**TECHNICAL EVALUATION SERVICES COAL
CONVERSION AND UTILIZATION-LIQUEFACTION.
RESEARCH AND DEVELOPMENT REPORT NO. 82,
INTERIM REPORT NO. 5**

PROJECT LIGNITE (PDU - STAGE)

RESEARCH AND DEVELOPMENT REPORT NO. 82
INTERIM REPORT NO. 5

Prepared by:
THE RALPH M. PARSONS COMPANY
100 West Walnut Street
Pasadena, California 91124

12. STRAIGHT SECTIONS OF PIPE INTO COOLER, E-3. Leak occurred at arrow near swedglock fitting. Material is 304 SS.

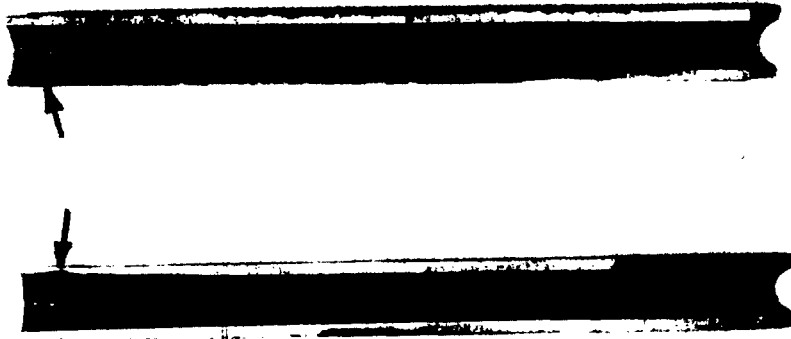
The straight section shown in Photographs No. 12 and 13 is of interest because no evidence of cracking was found. Instead, a very localized area of metal loss was found next to the brass swedge lock fittings (Photograph No. 14). The appearance of metal thinning accompanied by smaller pits suggest attack by some type of acid which was just slightly above the dew point in S-1 but subsequent cooling by the length of line between S-1 and E-3 brought the acid to its dew point, or the heat sink of the swedge lock fitting and cooler tube sheet caused a "fin effect" to bring the acid to its dew point.

If the acid is an organic-naphthenic then 316 SS and other molybdenum bearing stainless steels will provide good corrosion resistance. If acids are the strong inorganic types, stainless steels of higher nickel and chrome content may be required.

REMOVED FROM LINE CONNECTING TOP OF R-1A TO BOTTOM OF R-1B
 LOCATED NEAR R-1B INLET

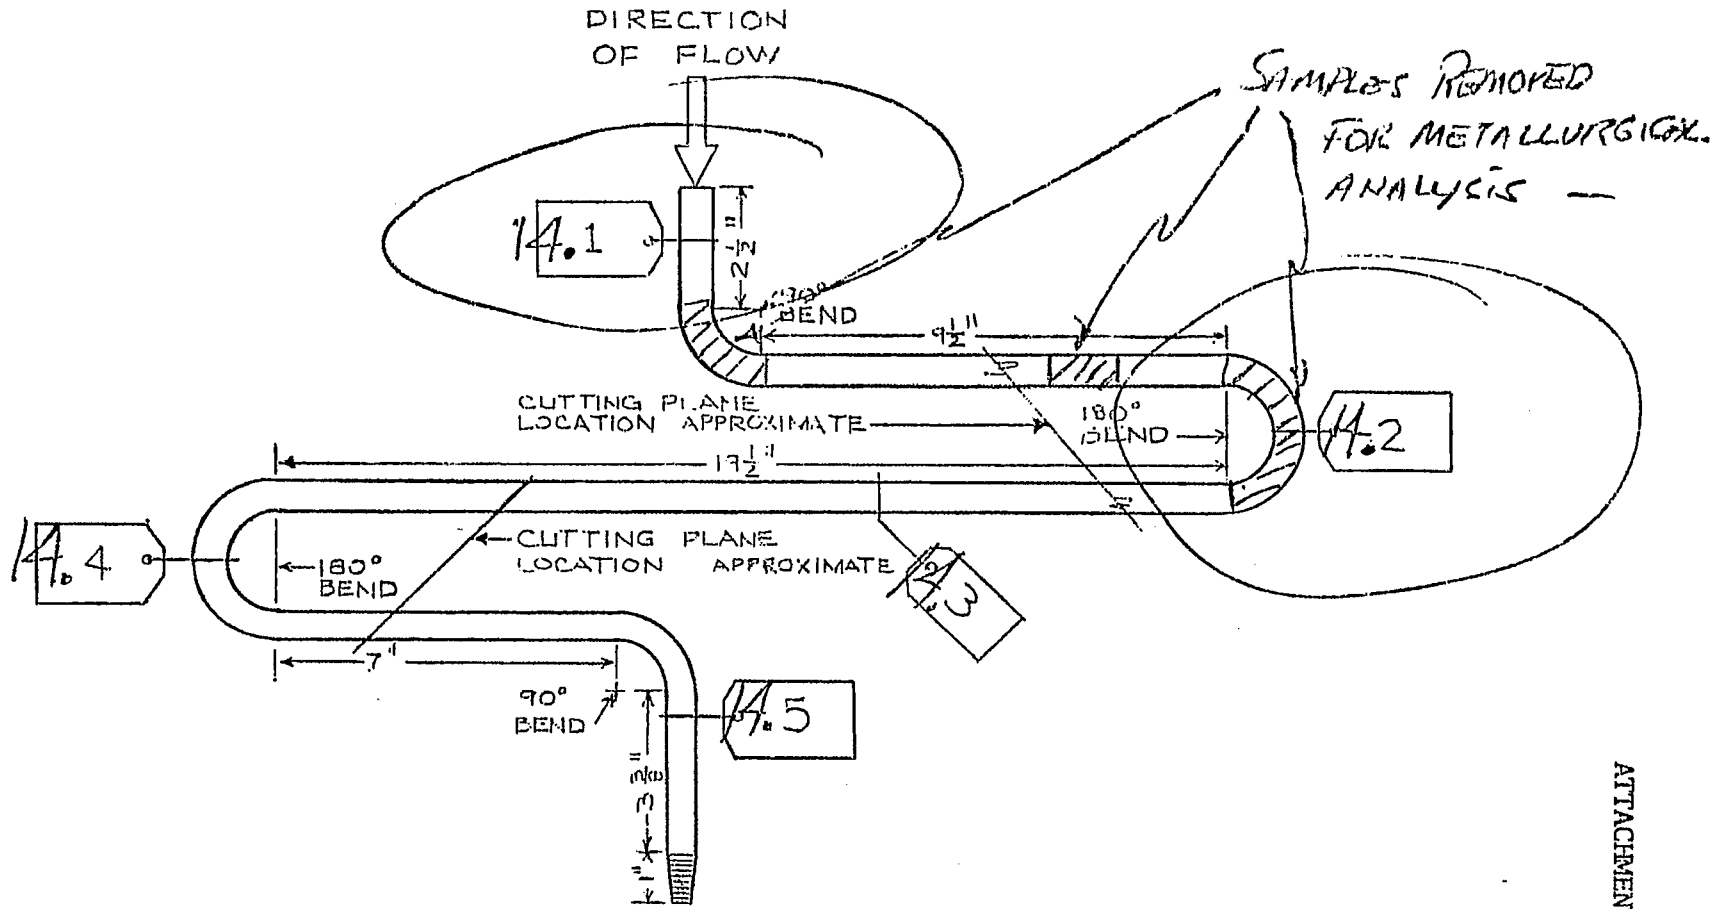
Samples from expansion piping between Dissolvers R-1A and R-1B were removed as noted in Attachment No. 1. Photographs No. 1 and No. 2 show numerous cold flow bands and extreme twinning indicating the presence of a high state of cold work. Cracks are transgranular with some tendency for branching but generally straight. Depth of cracks was about .030 inches. Location of cracks at the inside surface of the inside radius would suggest that bending stresses from expansion produced the necessary tensile stresses for cracking. However, we would have expected some cracking on the outside radius if bending from expansion created these stresses. Evidently, residual cold work and "spring-back" in forming the bends acted to oppose stresses caused by expansion and reduced tensile stresses on the outside radius.

Future expansion loops should be made of higher nickel alloys to resist chloride stress corrosion cracking. Incoloy 825 and Carpenter 20 Cb-3 would provide both pitting and cracking resistance. Depending on the

ATTACHMENT 2

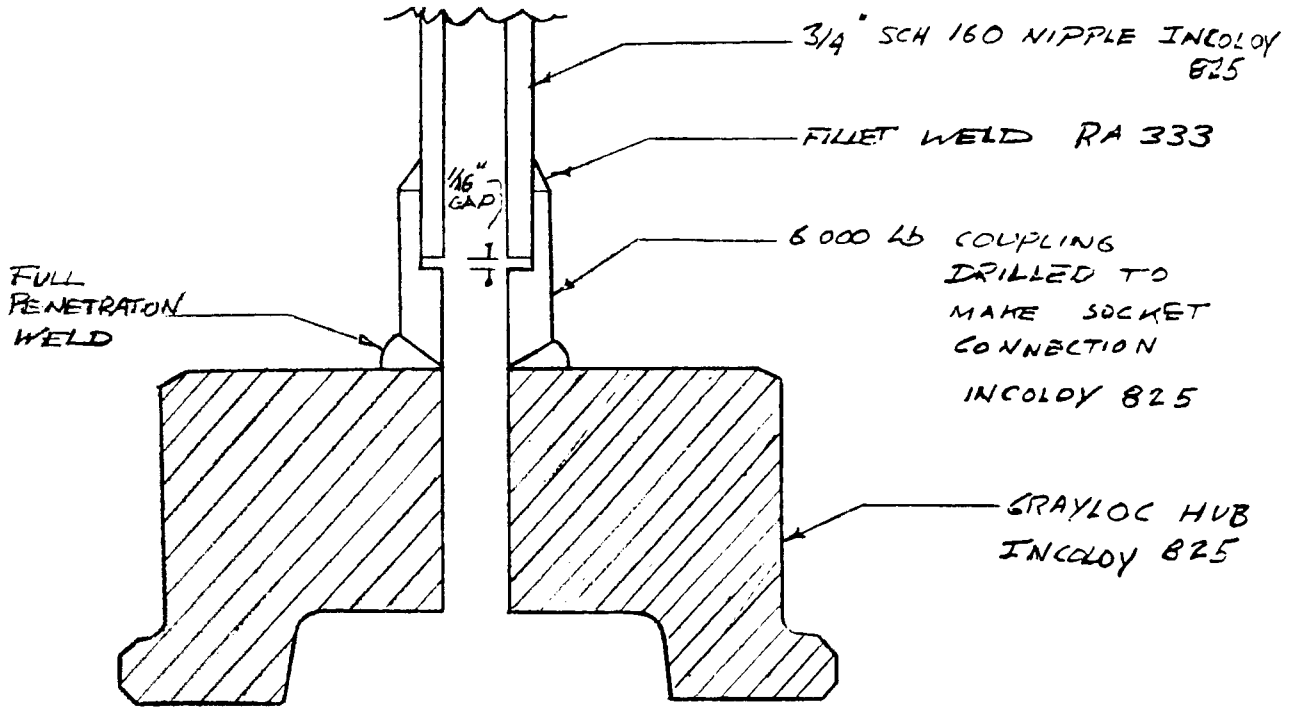
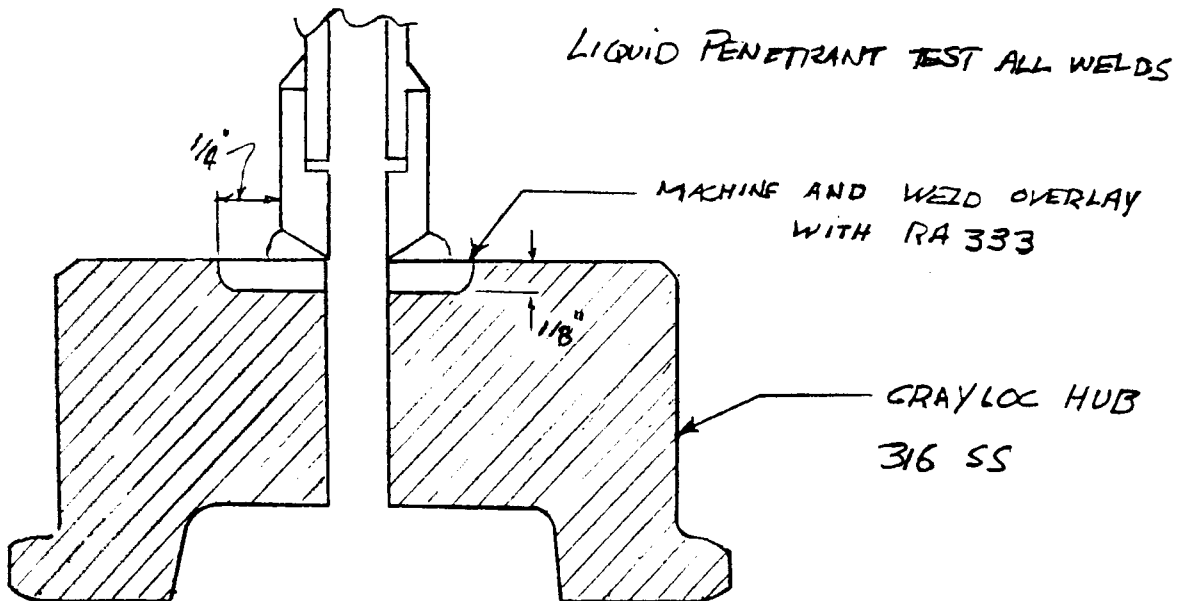
Cracks occurring in the 3/4-inch piping to the grayloc hub resulted in leaks and shutdown of the pilot plant. Further inspection reportedly found cracks in the tapped area of the hub.

These cracks could have been caused by chlorides but consideration also must be given to possible thermal fatigue. Insufficient clearance between the screwed pipe and the bottom of the tapped hole in the hub could result in "bottoming." Rapid changes in temperature would have caused the pipe to change dimensions faster than the hub and large stresses would have promoted thermal fatigue cracks in the fillet weld and hub.

1ST CHOICE - USE INCOLOY 825 HUB

2nd CHOICE - USE 316 SS HUB WITH RA 333 WELD OVERLAY -
